Addendum No.: 4

Bid#: 23-41-2

Project Name: Pearl River Diversion Canal Restoration

SHEET NO.
C1.0

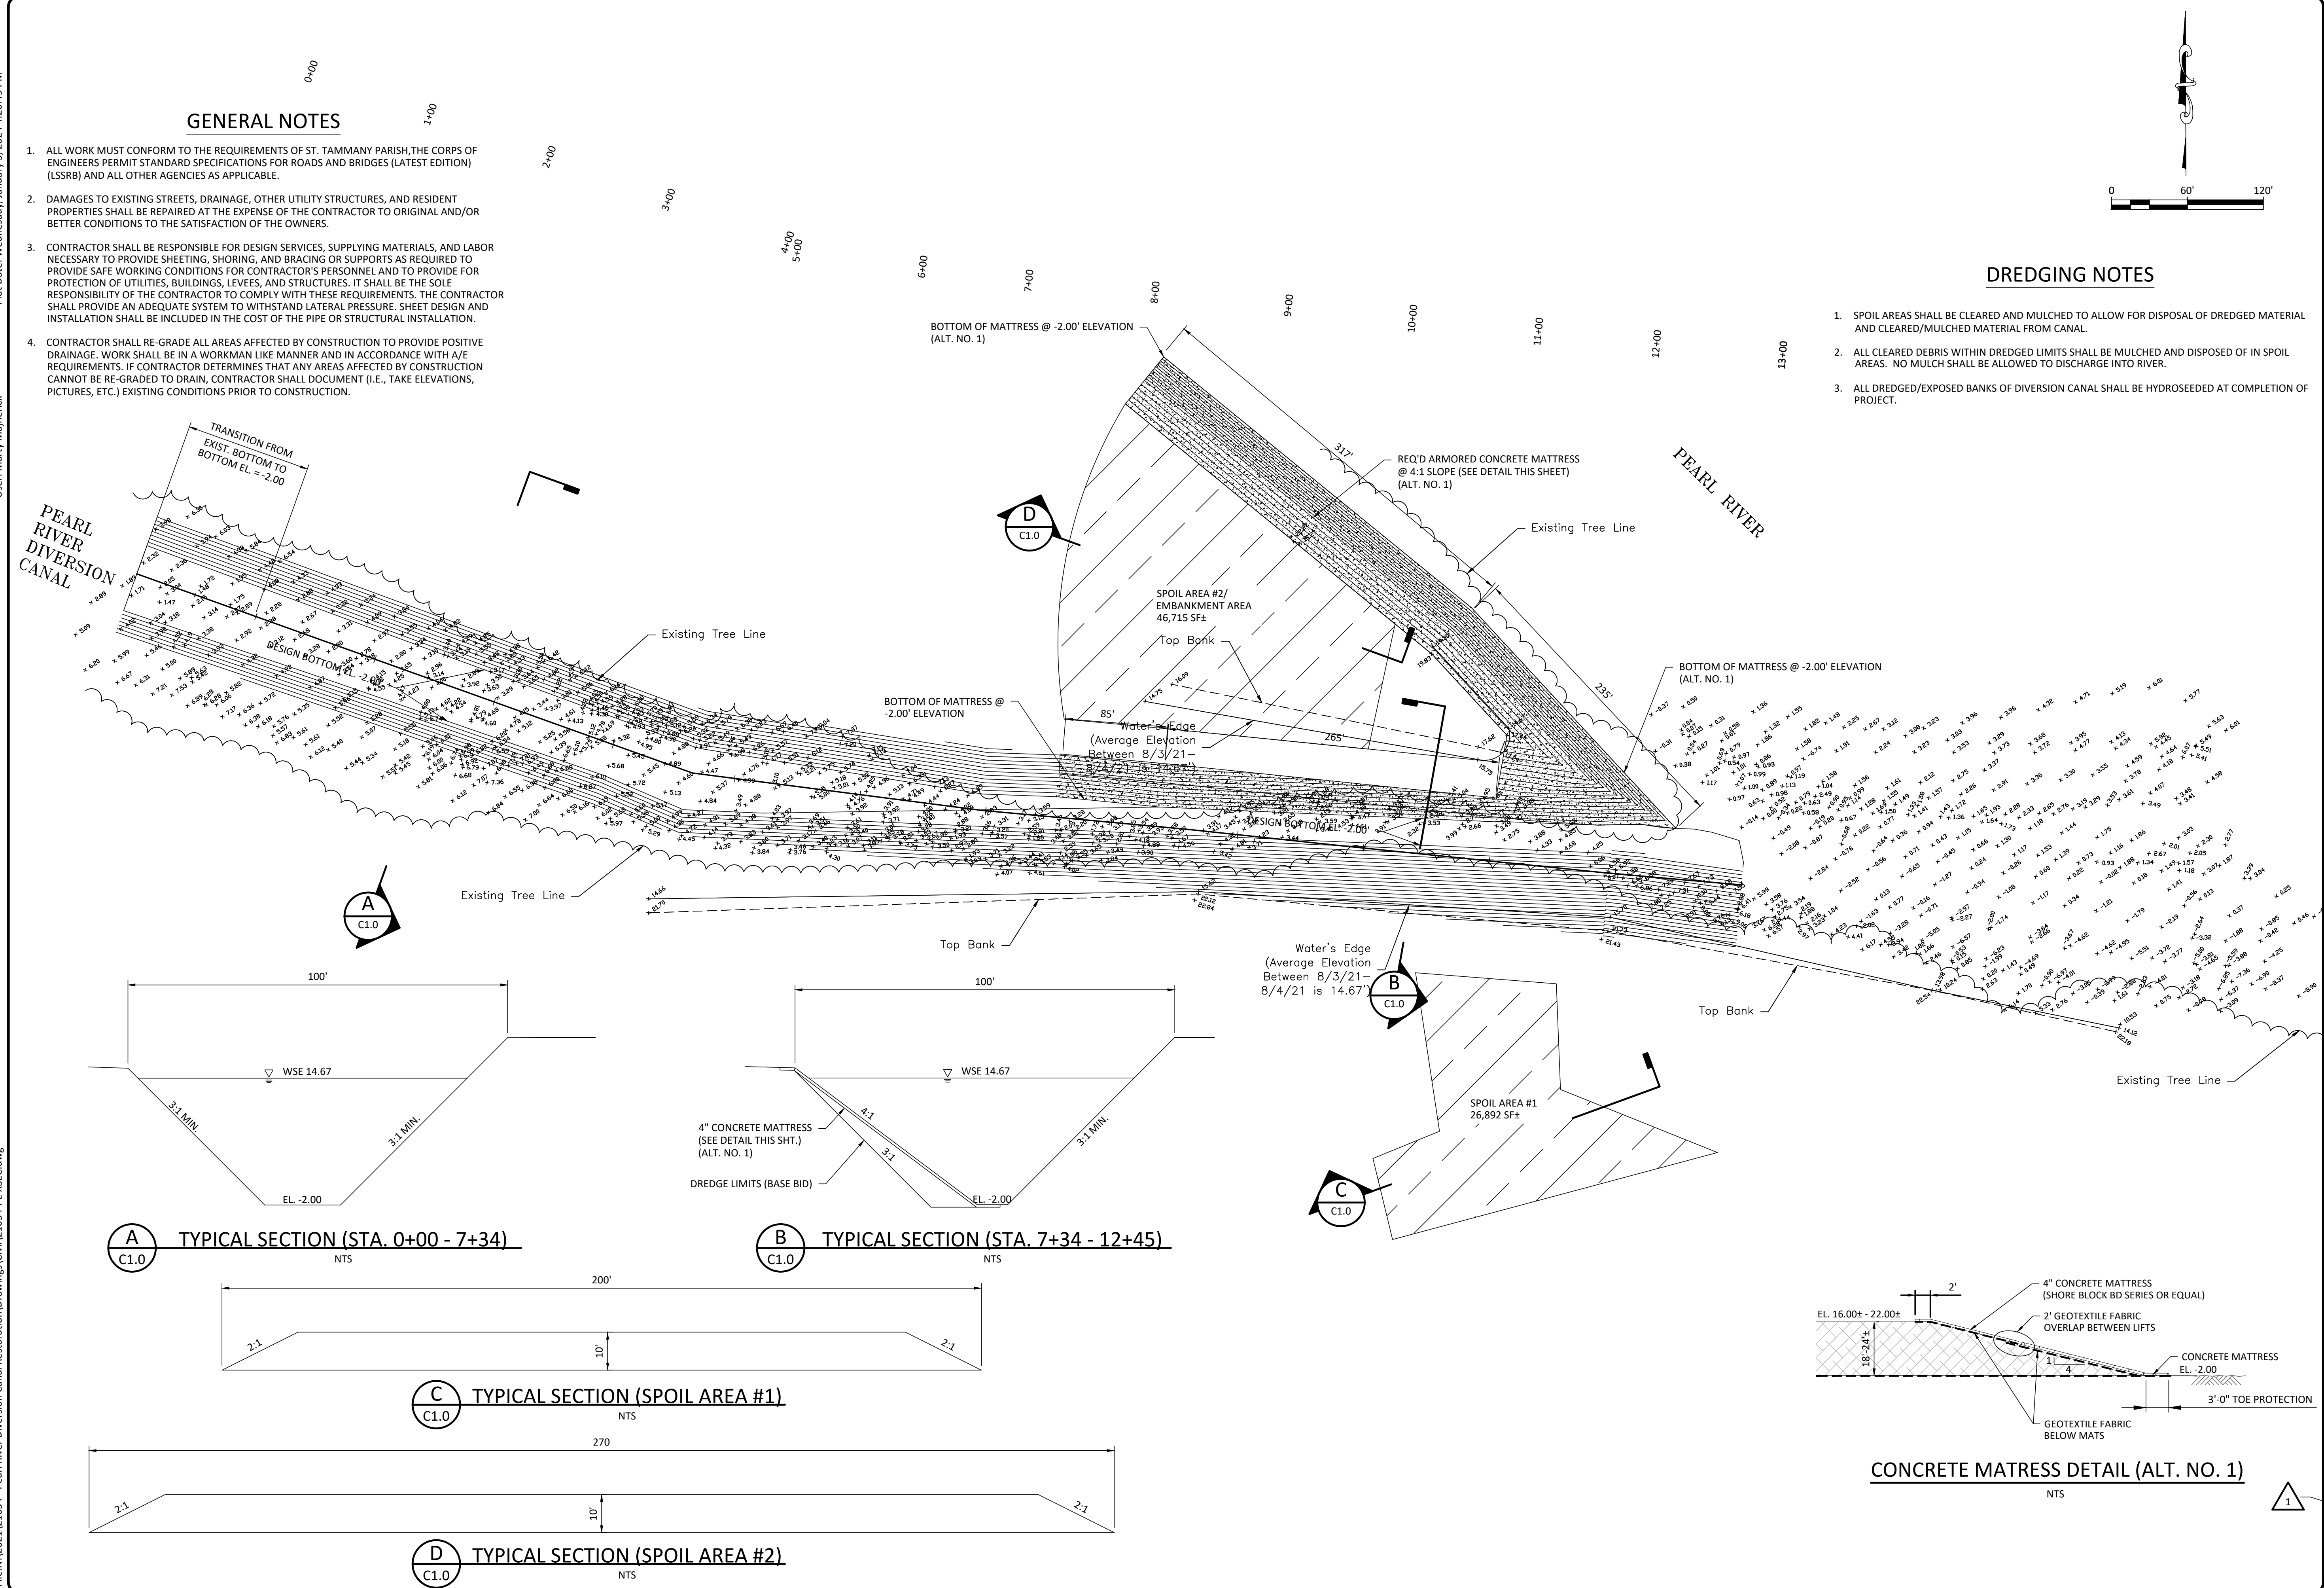
6. Remove Sheets C1.0 and C1.1 (dated 10/27/23) in their entirety and replace with Sheets C1.0 and C1.1 (revised 01/03/24) being included as part of this addendum. These drawings are being revised to reflect the reduction in width of canal dredging and to update the spoil areas available for this project.
7. Remove Sheets C2.0 thru C8.0 (dated 10/27/23) in their entirety and replace with Sheets C2.0 thru C8.0 (revised 01/03/24) being included as part of this addendum. The overall width of the canal dredging work is being reduced which reduces the quantity of excavation.
8. Remove Sheet C9.0 (dated 10/27/23) in its entirety as the limits of canal dredging is being reduced.

Answer 1: Clearing and grubbing now only needs to occur along the canal banks and within spoil area #2. This is approximately 2.6 acres. This is only an estimate and contractor shall clear and grub all areas necessary to facilitate construction per the documents. Spoil area #1 is restricted to areas that are already cleared. See revised sheets c1.0 and c1.1.
